8050A

Digital Multimeter

Instruction Manual

CHANGE/ERRATA INFORMATION

Figure 1.

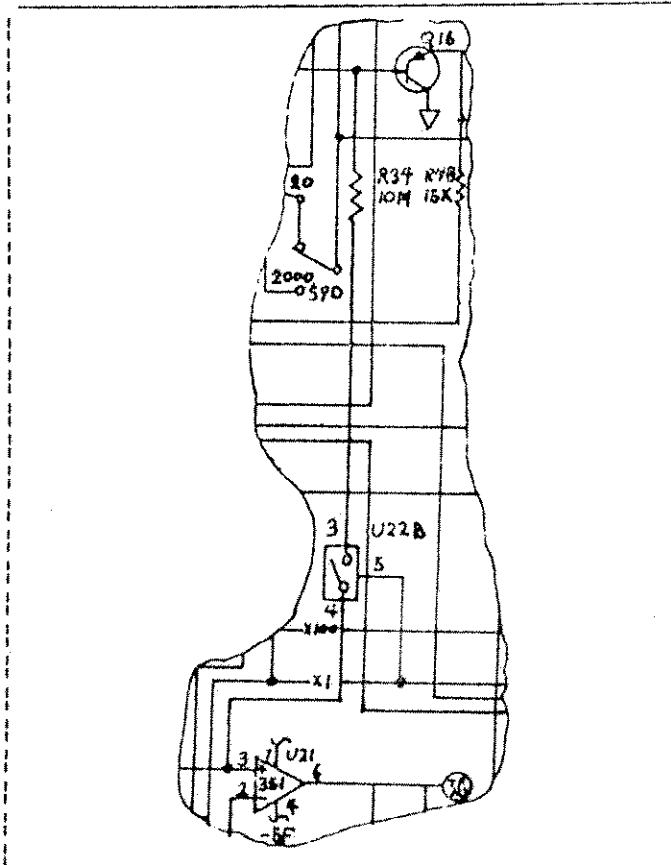
On page 7-6:

Delete U22B and all connections to it.

Add U22B and R34 as shown in Figure 1.
